UNITED STATES PATENT AND TRADEMARK OFFICE

10/824,436

Office Action Summary

DETAILED ACTION

FIG.4

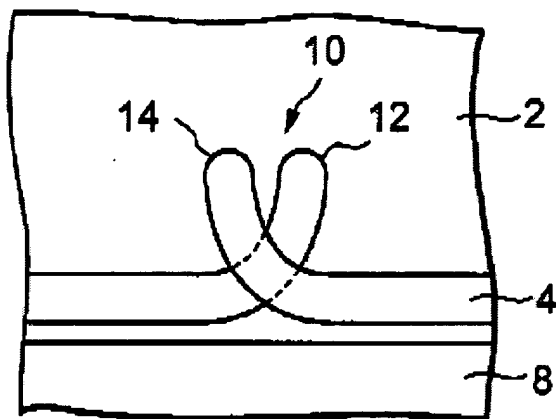
4. **Claims 1, 2-6 and 9-20 are rejected under 35 U.S.C. 102(b) as being anticipated by Yoshizoe, US 2003/0025867.**
5. Yoshizoe discloses and shows in Fig. 4, a seal pattern structure for a liquid crystal display panel, comprising:
 - a substrate (2) having at least one image display part (8);
 - a start pattern (12) formed from a point spaced apart from the image display part to a point adjacent to an outer edge of the image display part;
 - a main pattern (4) connected to the start pattern and encompassing the outer edge of the image display part; and

- an end pattern (14) connected to the main pattern and formed from the outer edge of the image display part to a point spaced apart from the image display part, wherein a connection part between the start pattern and the main pattern and a connection part between the main pattern and the end pattern cross each other.

Yoshizoe also discloses and shows in Fig. 4 that the start pattern (12) and the end pattern (14) overlap each other and are spaced apart from the display region (8) and that the seal pattern is formed on a first substrate, the liquid crystal material is dispensed inside the closed loop formed by the seal pattern and then a second substrate is adhered to the sealant. Further, a method of forming the seal pattern on a substrate for a liquid crystal display panel merely discloses the step of forming each

Yoshizoe further shows in Fig. 4 that the start pattern, the main pattern and the end pattern are connected in round form and that the start pattern and the end pattern are formed to be substantially parallel and symmetric with each other and that a distance between the start pattern and the end pattern gradually increases with the distance from the connection part.
